**SUBJECT: TecJet 50+ and TecJet 52 (1<sup>st</sup> Gen) Product Support Statement**

This product support statement is applicable for all TecJet 50+ and TecJet 52 (1<sup>st</sup> Gen) variants only. I.e. this statement is **not** applicable for TecJet 50+ PLF, TecJet 85, TecJet 110, and TecJet 52 (2<sup>nd</sup> Gen).

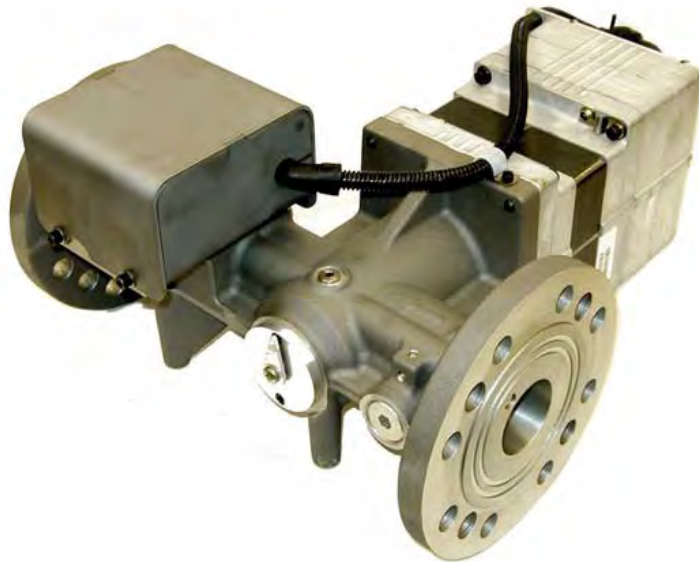
The key differences between the 1<sup>st</sup> and 2<sup>nd</sup> generation of TecJet 52 can be identified by:

- TecJet 50+ and TecJet 52 housings are made from a single casting.
- TecJet 52 (2<sup>nd</sup> Gen) is based on 35-pin F-Series ITB with mating flanges.

- Increased turndown ratio (from 65:1 to 110:1)
- Lower closed flow leak (20% closed flow area reduction)
- Improved environmental sealing
- More robust for special gases (improved bearing specification)
- Lower weight (31 lbs instead of 40 lbs)
  - Less vibration sensitive

Table 1. provides TecJet 52 (2<sup>nd</sup> Gen) part numbers that can be used to replace the TecJet 50+ and TecJet 52 (1<sup>st</sup> Gen).
